July 1, 2021

ADDENDUM No. 1

Oregon Central Fire Station

S2.0

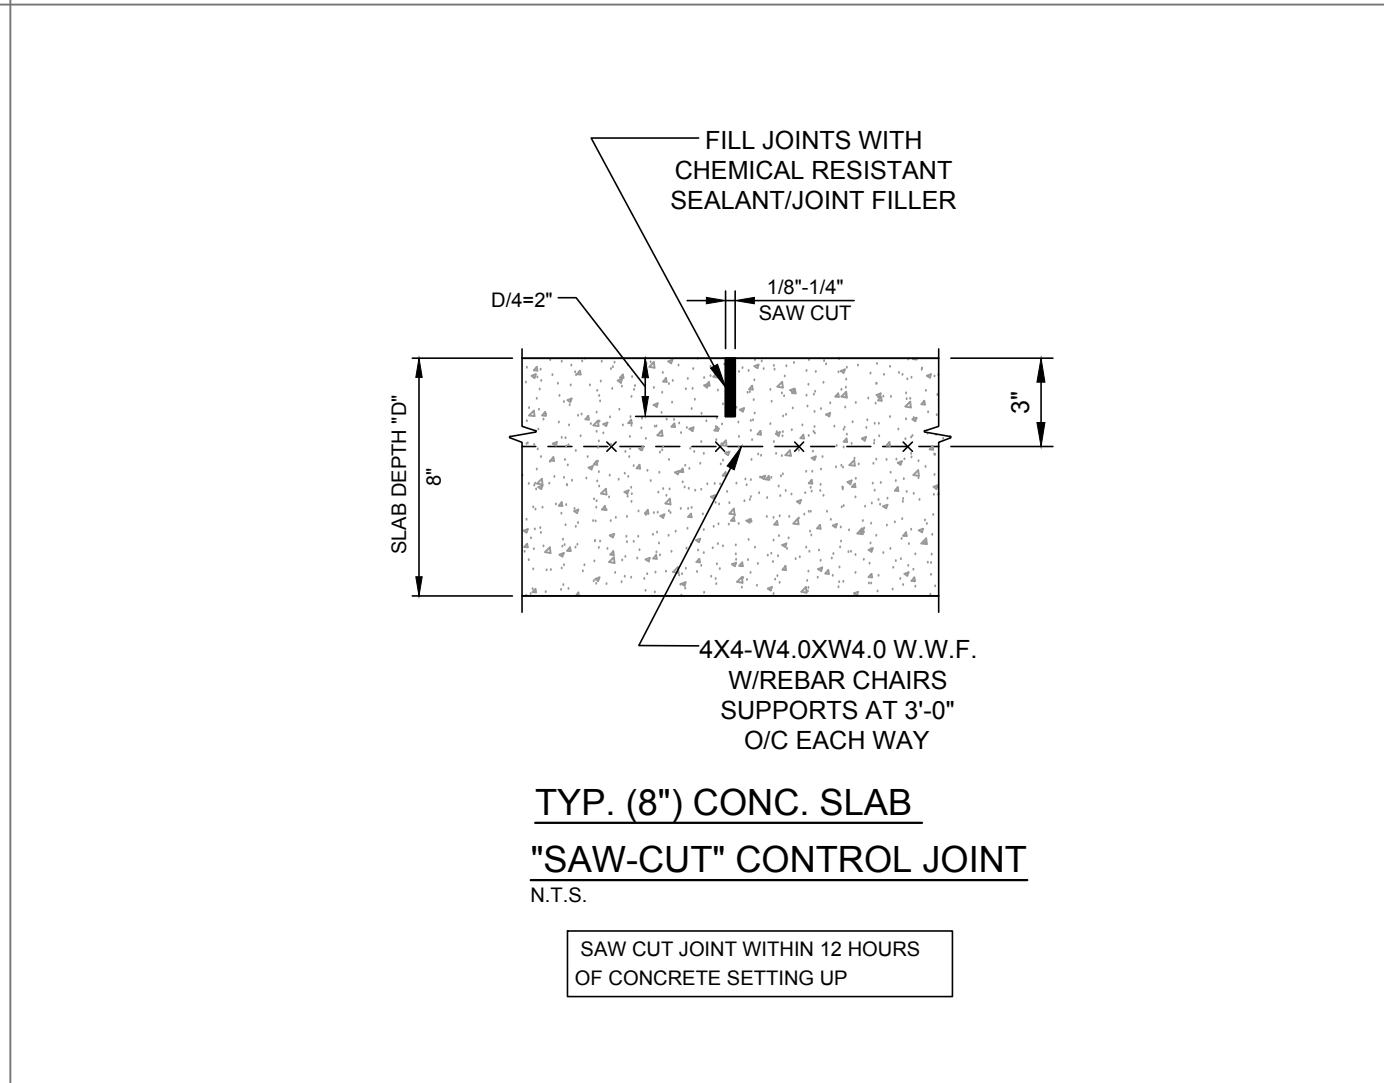
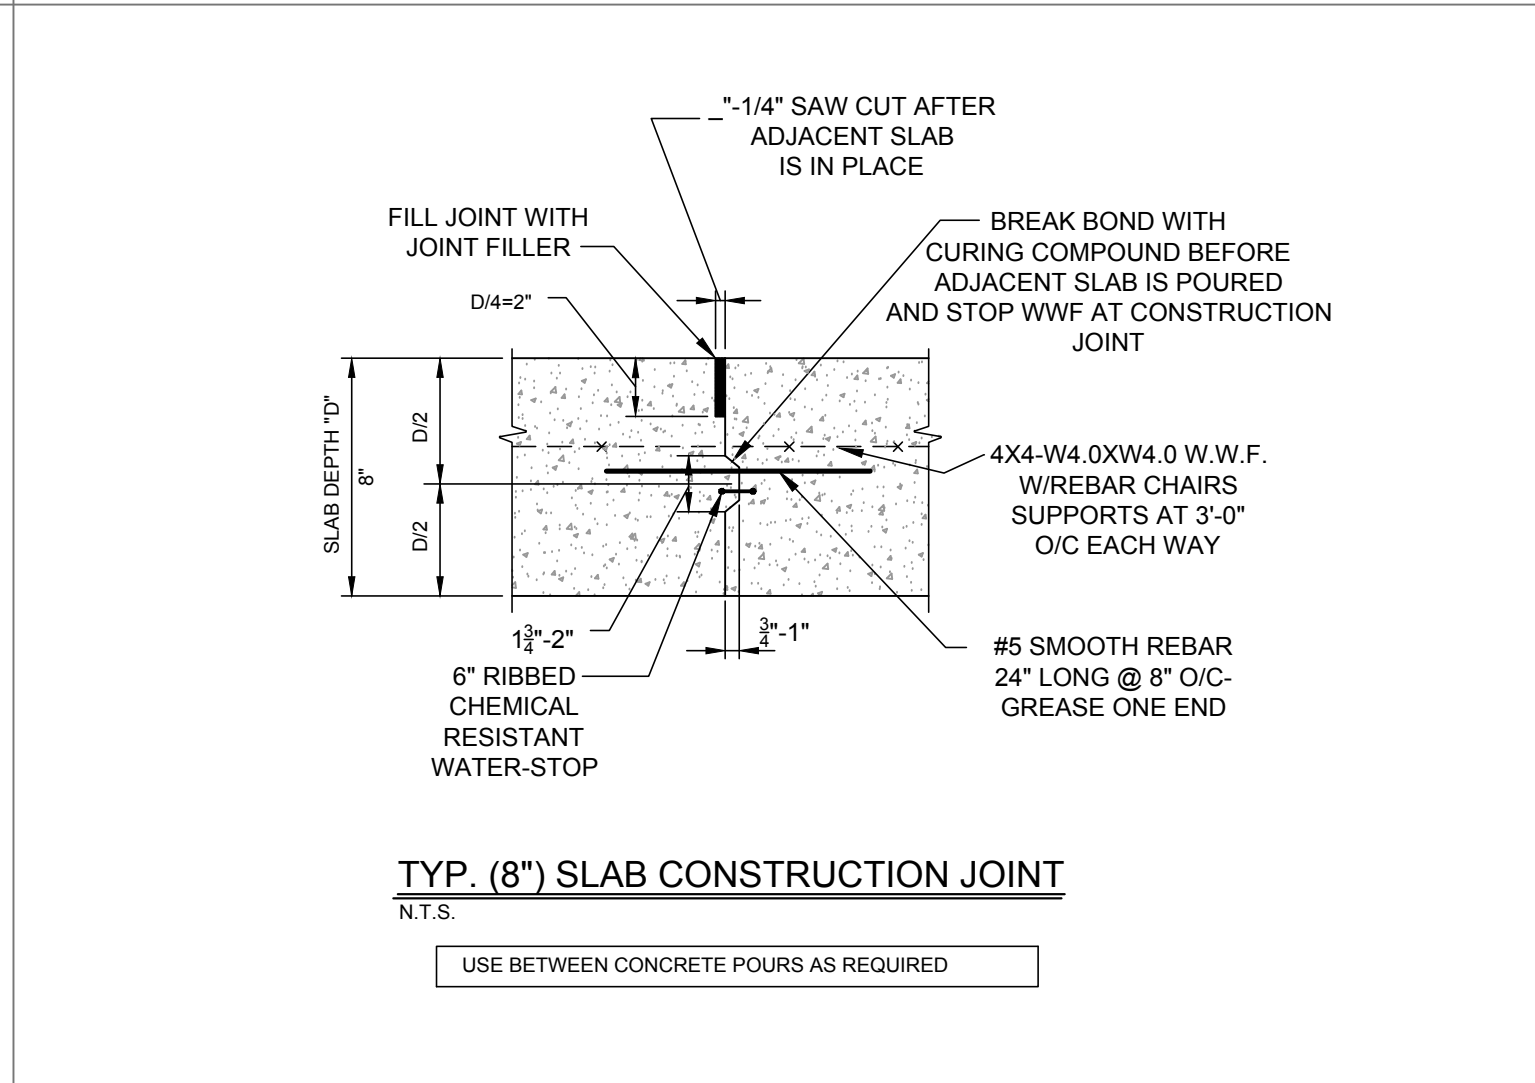
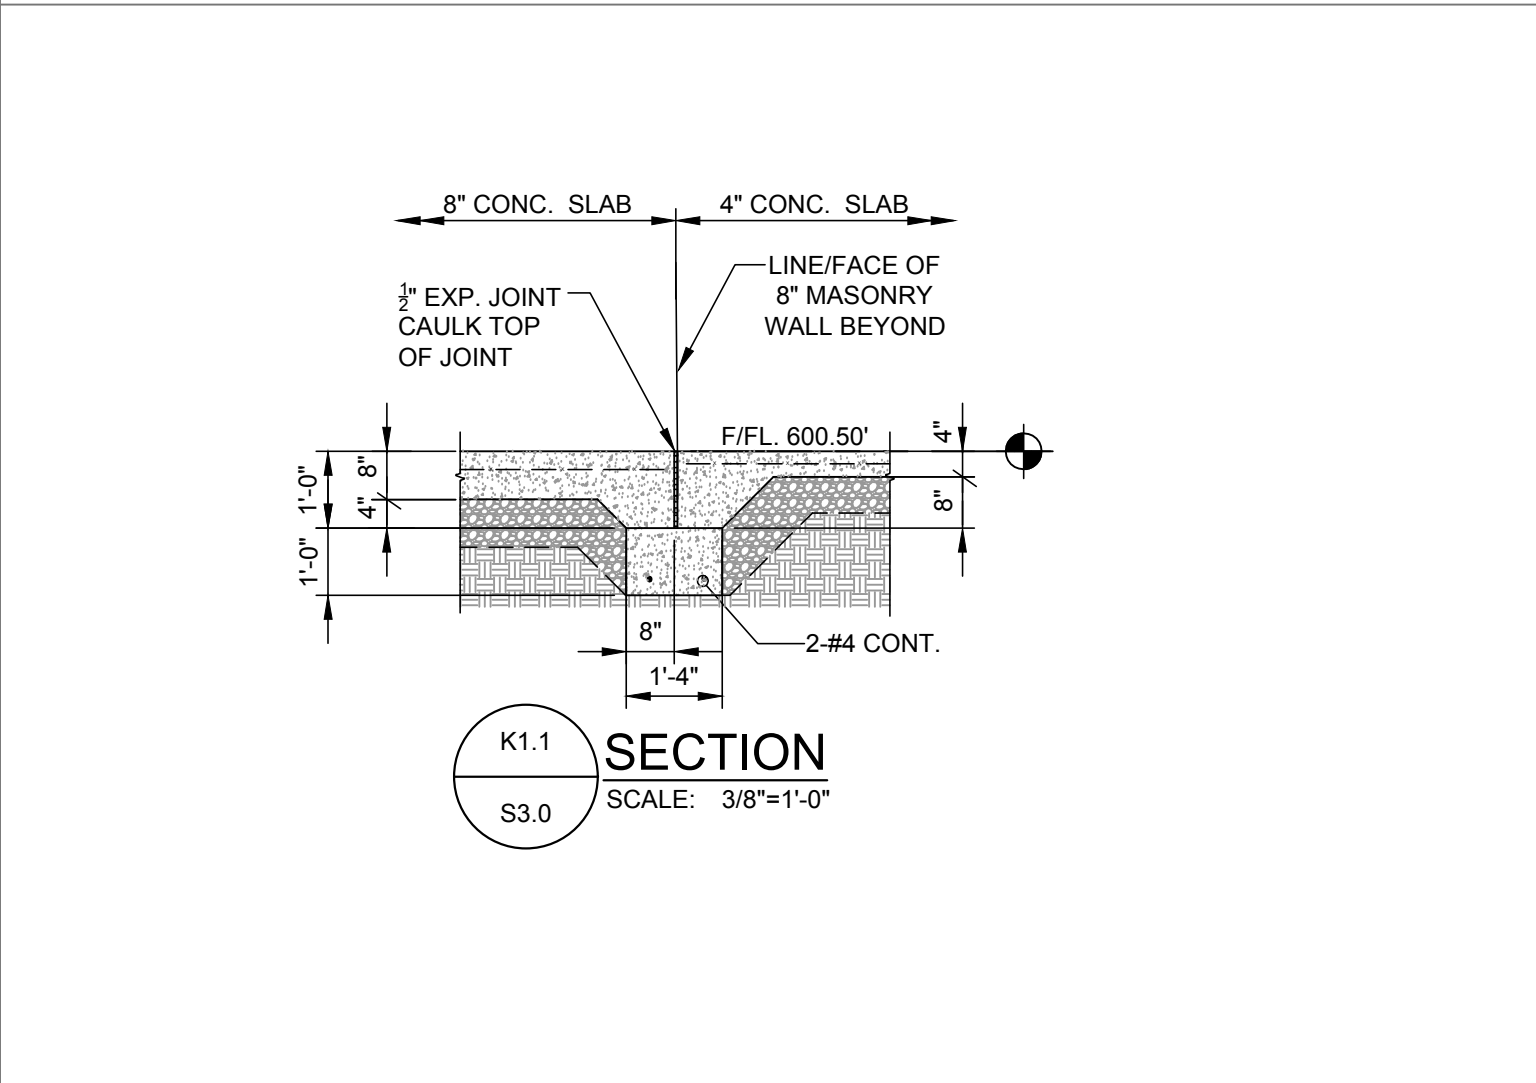
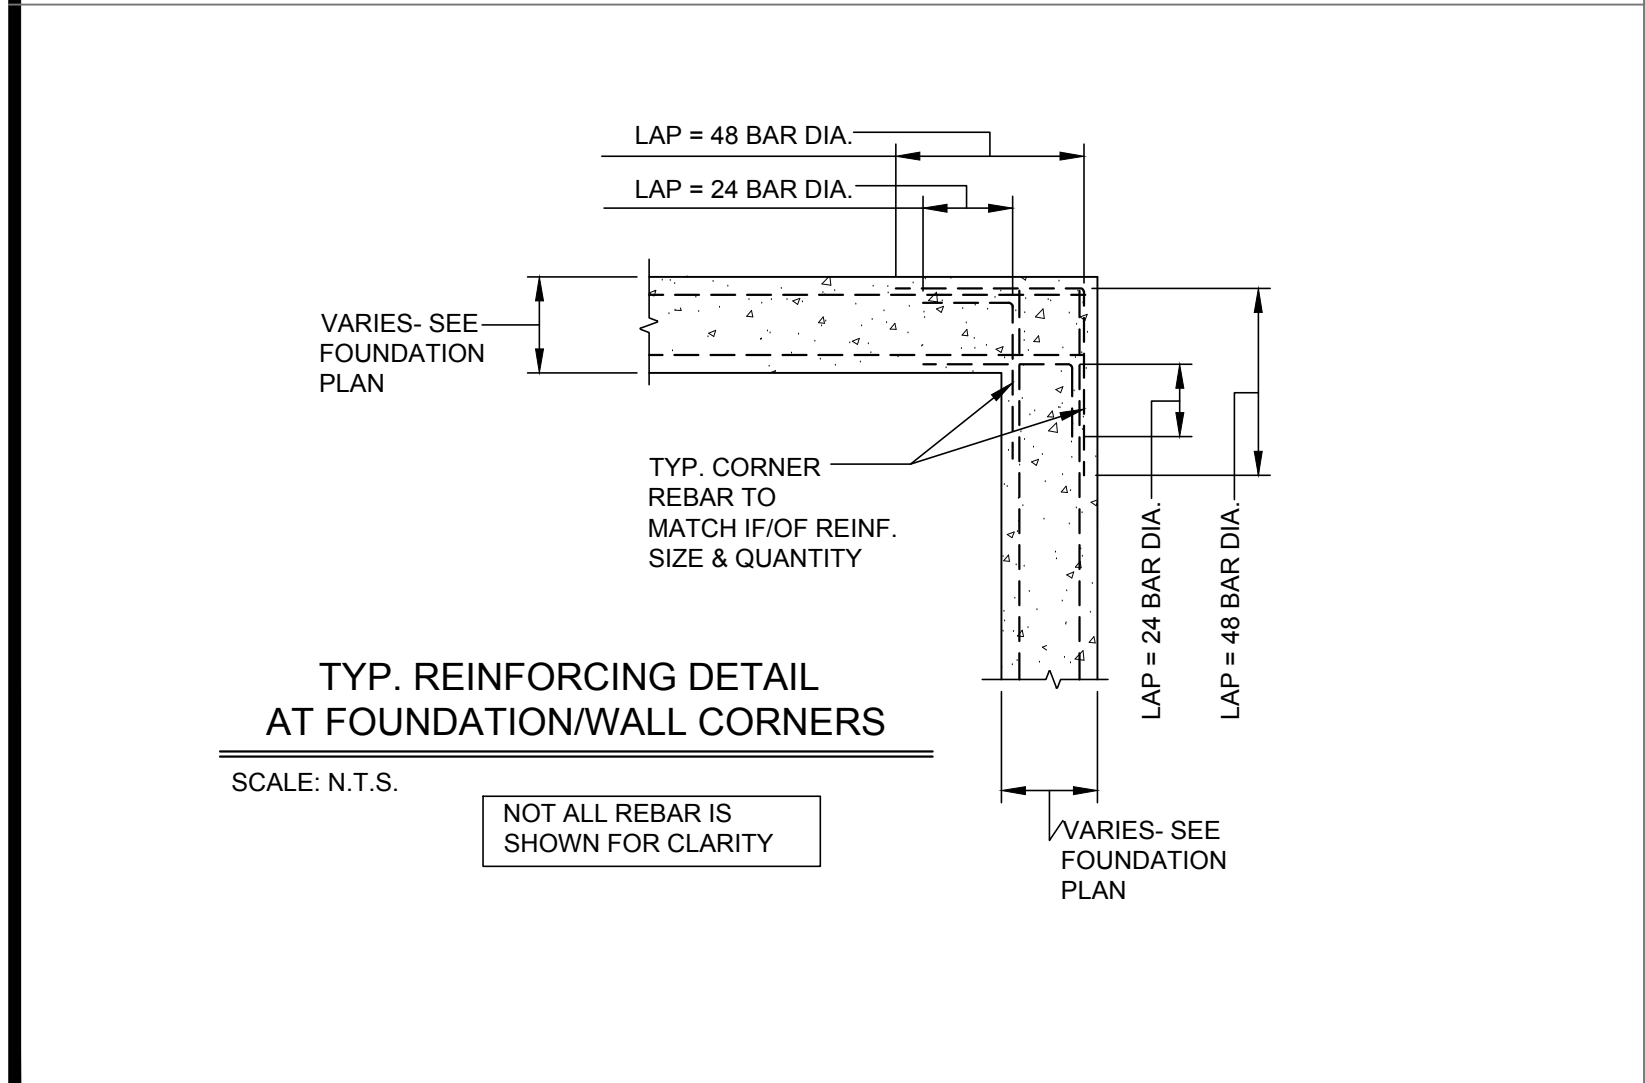
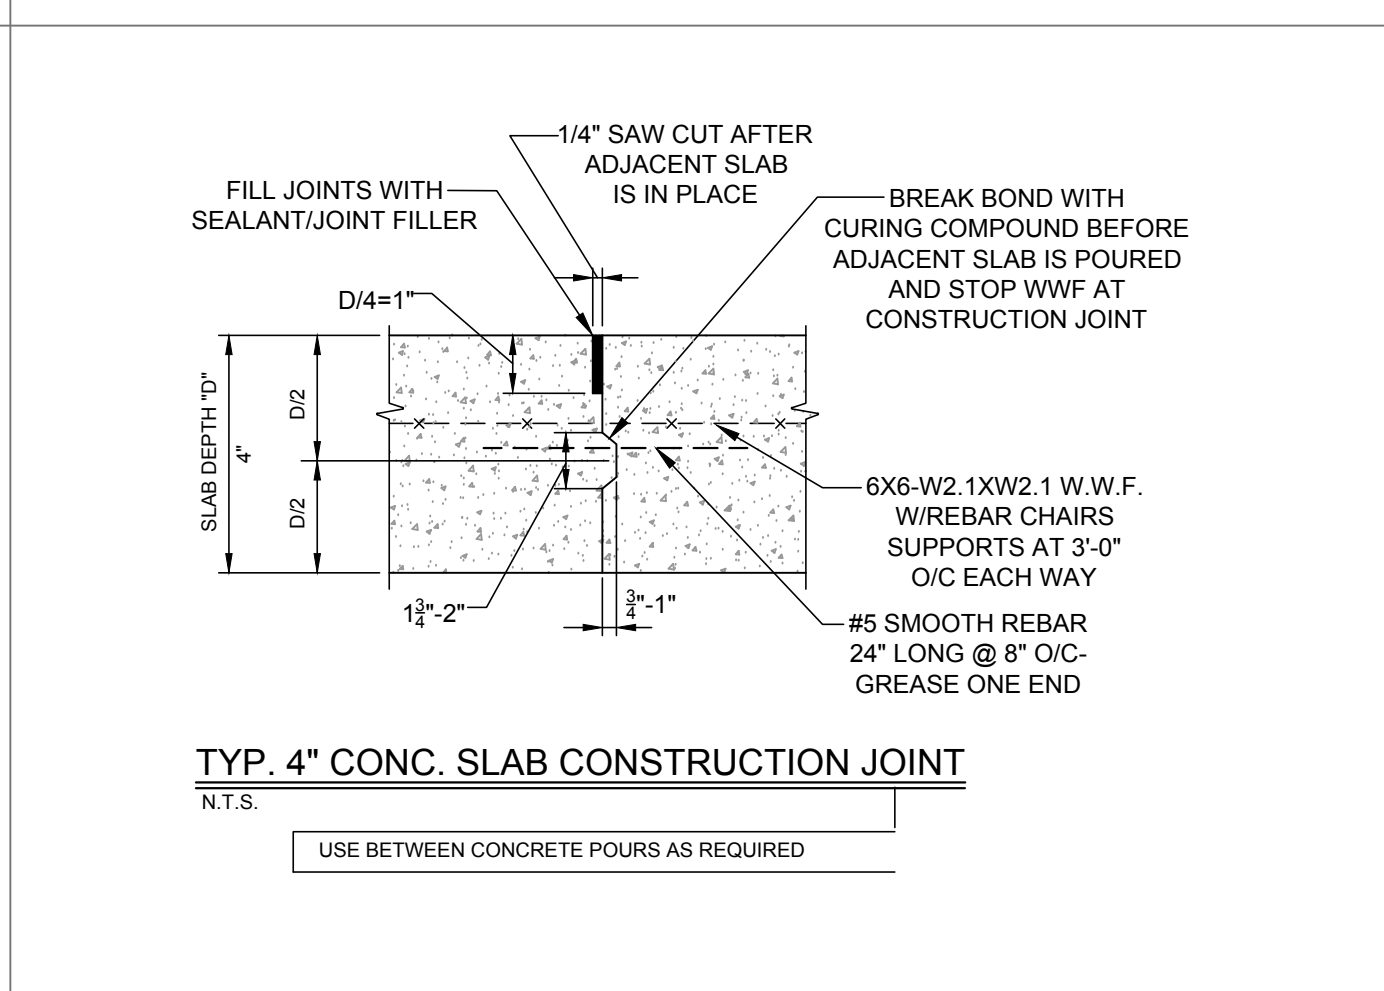
- See attached revised drawing S2.0 for window lintels.
